Release note

Product: PTC310/PTC310H/PTC310U/PTC330/PTC330U

PTC310N/PTC310HN/PTC310UN/PTC330N

FW version	V.47
Release date	20221110
New features	1. none
Improvements	<p>1. Bug fix: TR311HN NDI functionality will be blocked when upgrading to V45 firmware.</p> <p>2. Correction Japanese language of OSD menu.</p> 
Known Issues	<p>1. Web page compatibility issue with the Apple MAC Safari browser. Please use the Chrome browser on Apple devices in the meantime.</p> <p>2. USB port does not yet support Hot plugging.</p> <p>3. When the video mode is set to IP streaming only or NDI only; then when the USB port is connected to a PC, users will still see the device name on the PC side but there's no USB video (UVC) output.</p> <p>4. HTTPS/port 443 does not work despite HTTPS is enabled at web UI.</p>

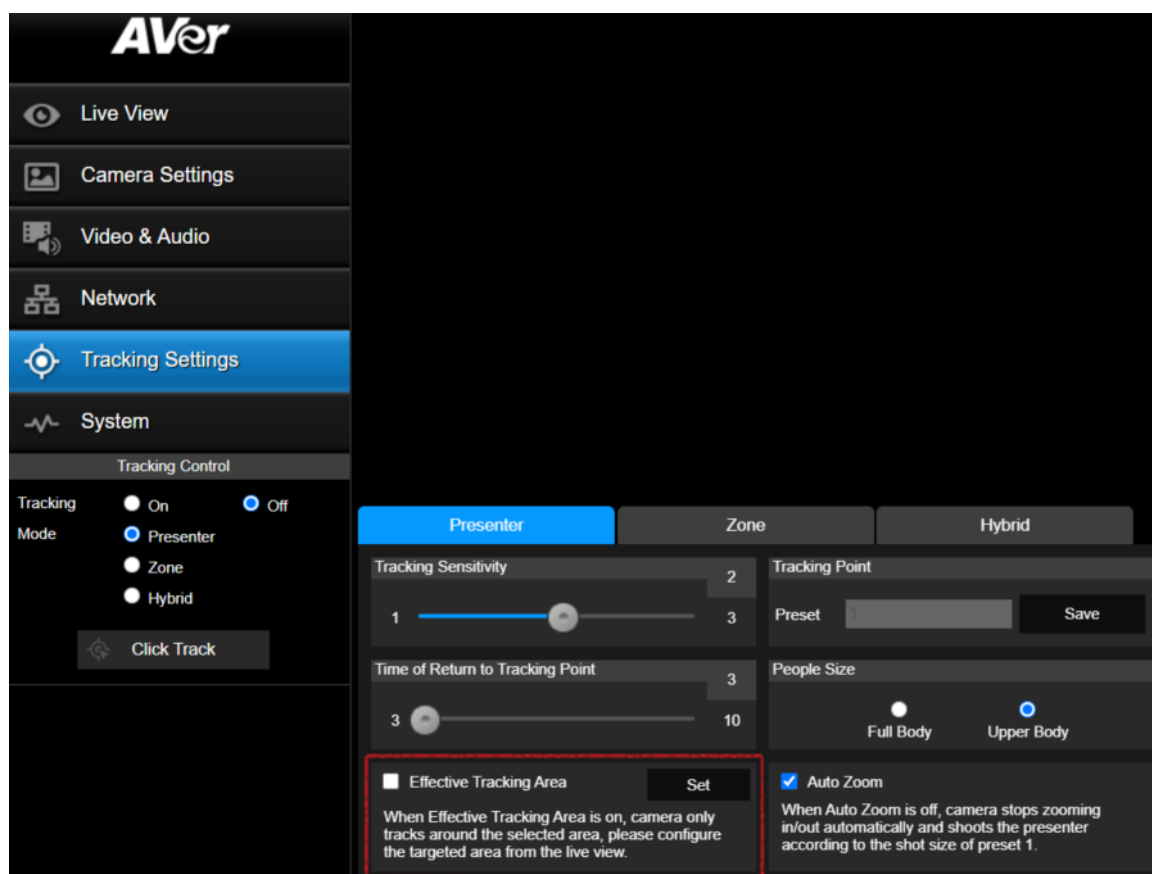
FW version	V0.0.0000.30
Release date	2021/4/6
New feature	<p>10. Added Power Up to Preset position setting on Web UI.</p> <p>11. Added Power Off to Preset position setting on Web UI.</p>  <p>12. Added Tracking mode SET & GET mode commands to the CGI/VISCA command list.</p> <p>13. Added ability to change “Hostname” of camera on Web UI.</p>  <p>14. Relocated the Tracking Controls to the Main Menu on the Web UI.</p>  <p>15. Added Effective Tracking Area function in Presenter Mode. If this is checked, the camera can be programmed to only track the subject within a predefined area of its view.</p>

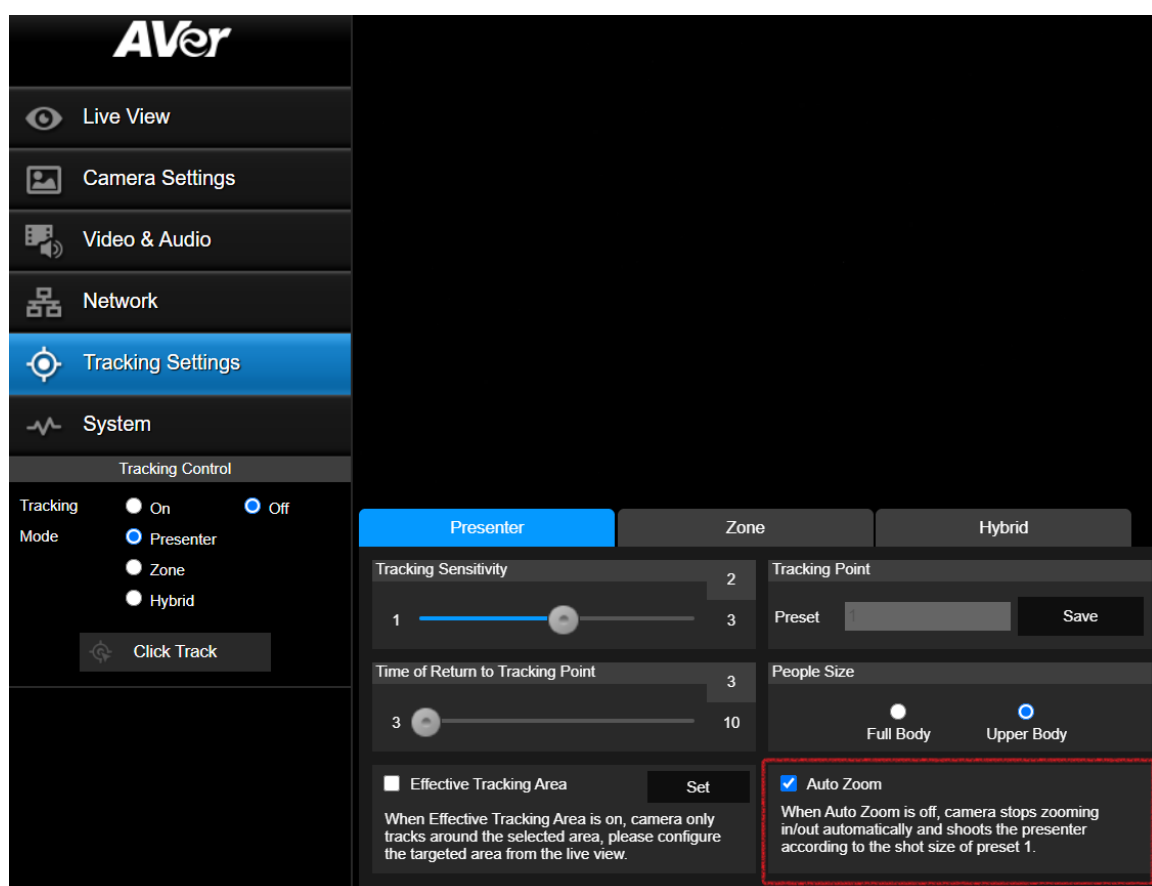
16. Added Auto Zoom Enable/Disable function in Presenter Mode. When checked, the initial zoom value once subject is acquired is preserved throughout the tracking experience.

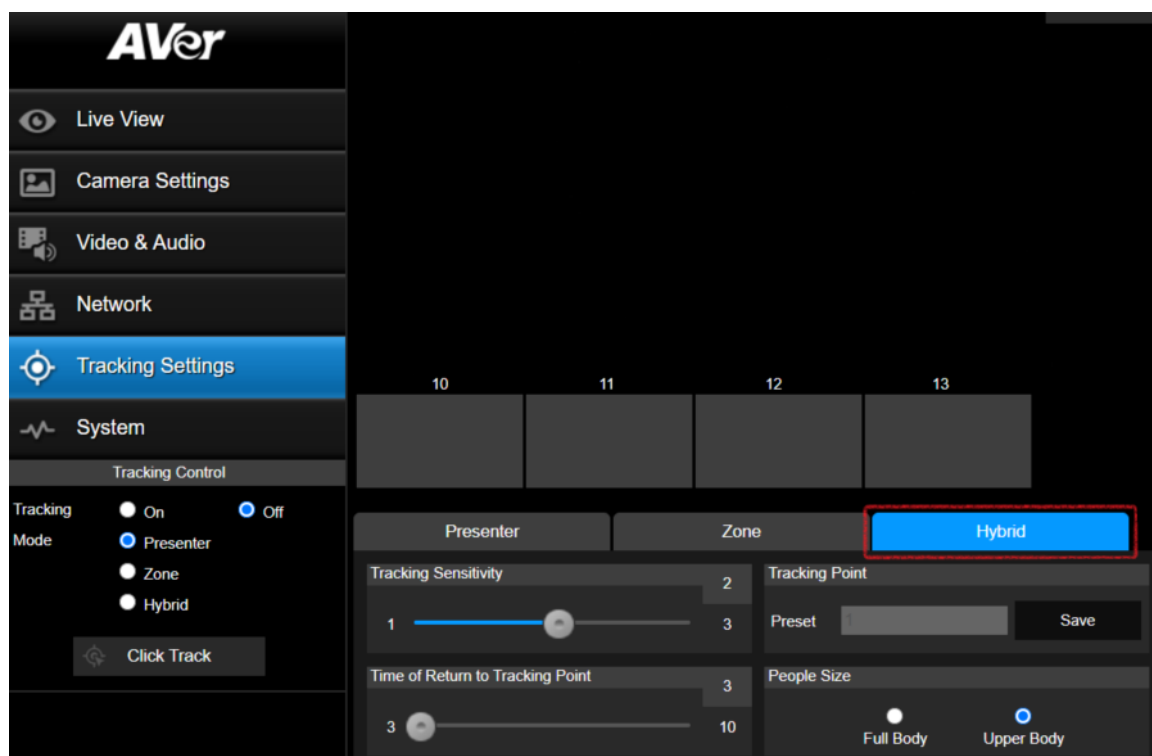
17. Added a new “Hybrid Mode” Tracking feature. This feature combines the best features of both the Presenter Mode and the Zone mode. Preset 10 through 13 is preserved for the Zone mode feature where the camera will automatically toggles to Zone mode whenever the subject is within those preset zones. When the subject is outside of those predefined zones, the camera automatically switches to “Presenter mode”.

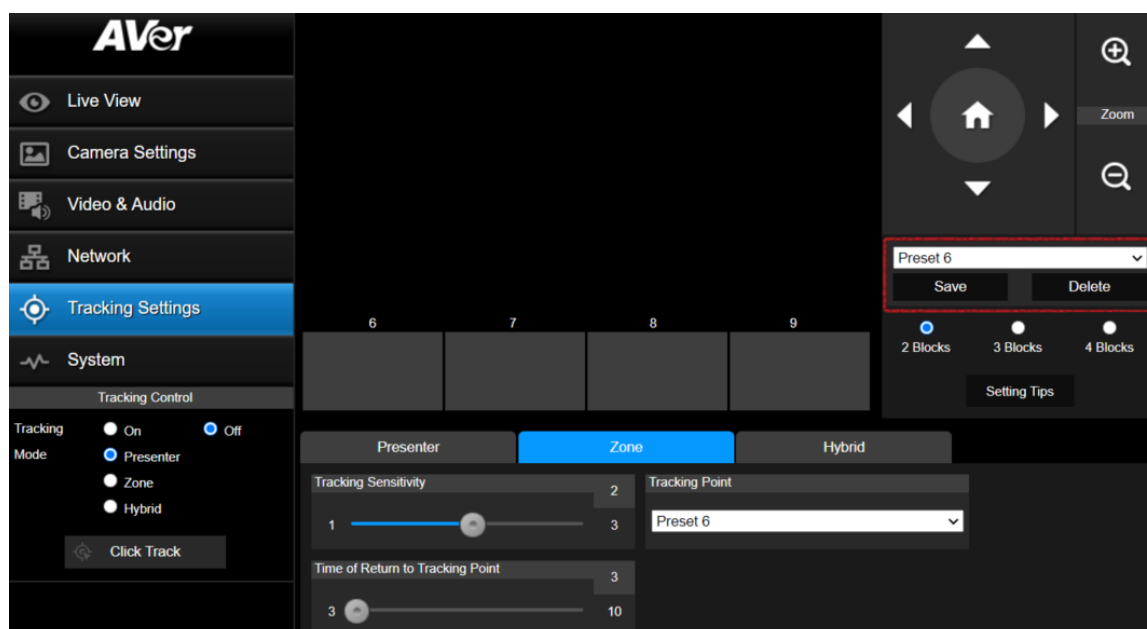
18. Added and improved on the method to “Save/Delete” presets in the Zone and Hybrid Mode setup screen.
